## AGENDA CITY OF CEDAR FALLS, IOWA PLANNING AND ZONING COMMISSION MEETING WEDNESDAY, DECEMBER 08, 2021 5:30 PM AT CITY HALL AND VIA VIDEO CONFERENCE

2. College Hill Design Review for Kwik Trip Remodel at 2019 College St. (DR21-009)

**SUBJECT:** Façade and signage updates in the College Hill Neighborhood Overlay District

**SUBJECT:** PP21-007 West Viking Road Industrial Park Phase V Preliminary Plat

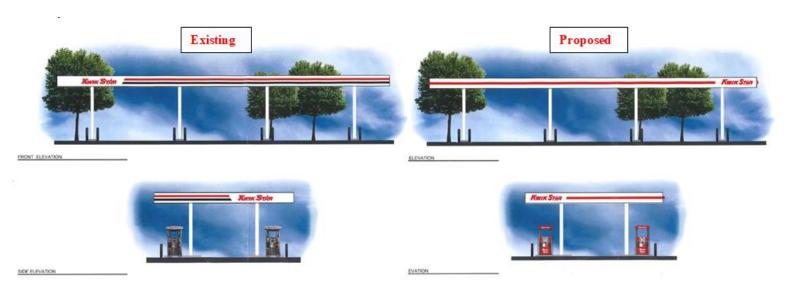
Image to left shows the impression of the gas canopy in the nighttime. The picture depicts that the Red LED strip on the gas canopy might create nuisance if the site is surrounded by residential uses like College Hill Neighborhood. Generally, gas canopies tend to be overly lit, as the intent is to get a customer from a distant. With addition of LED strip on gas canopy will further lead to more lighting on site creating nuisance.

Also sign code states that the sign should be located in a manner that it is downcast on site and is not illuminating towards neighboring properties.

Overall, staff finds that the improvements proposed would enhance the overall look of the site but the LED strip on the gas canopy needs to be replaced with a red vinyl band or red color band without any illumination to preserve the character of the College Hill Neighborhood and more importantly to prevent nuisance light. City staff notes that separate sign permits will be required to review and approve gas canopy signage.

Staff recommends approval of the submitted College Hill Neighborhood application for updating façade materials, gas canopy and signage for Kwik trip at 2019 College Street provided that the LED light strip is removed from the design of the canopy.

PROPOSED CANOPY ELEVATION

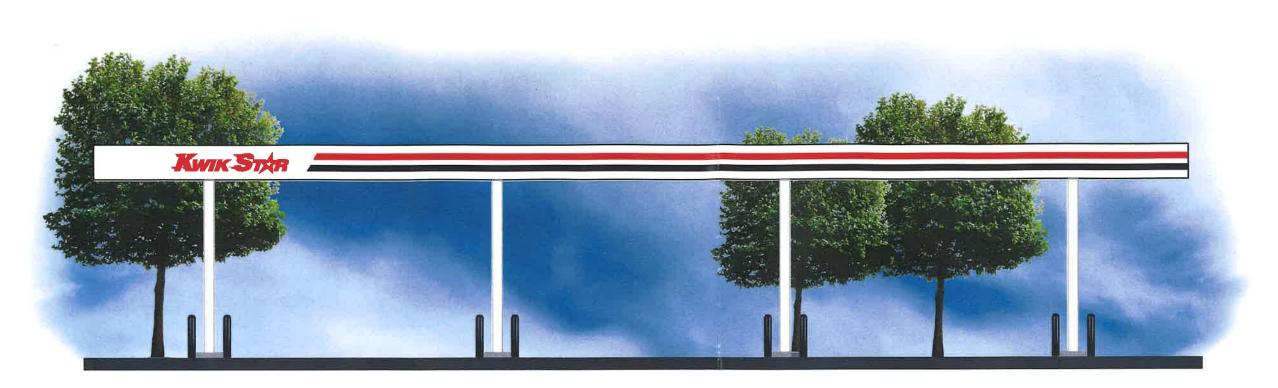
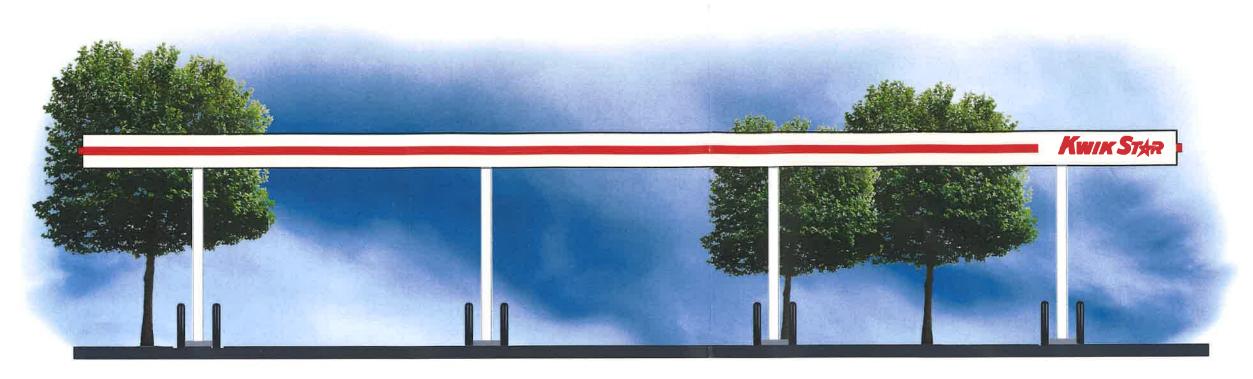
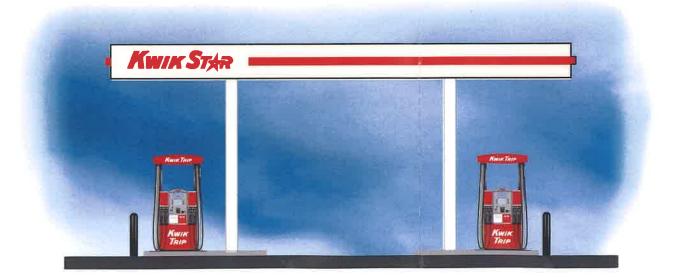
Part of proposal includes updating existing canopy siding with red and blue vinyl stripes with new tan metal fascia panels and red LED stripe for branding purposes. The new 8 inches LED strip and channel letters will be lighted. City staff finds that the proposed red LED strip in the periphery of the gas canopy would be a nuisance for surrounding residents, as most of the adjacent areas are residential in nature and the area east of the site along College Street has residential units above commercial storefronts on the main level that would be directly affected by the LED lighting. City staff finds that the proposed look is more appropriate for highway or peripheral areas of the city and is not appropriate within a neighborhood context. Staff suggests finding alternatives such as adding a red band with no illumination which would respect the new branding and character of the College Hill Neighborhood without the nuisance effect. The proposal also includes updating new red wrap on fuel dispensers that would match the new theme of the store/franchise, which would be a good way to enhance the site.

Notification of this case was sent to adjacent property owners on 12/01/2021. Staff suggests finding non-illuminating alternatives to Red LED strip on the gas canopy to preserve the character of the neighborhood. Staff notes that the applicant will have to apply for required building permit and sign permit to make necessary changes as per the proposal on site. Permits will be approved and released, once we get approval from both Planning and Zoning Commission and City Council.
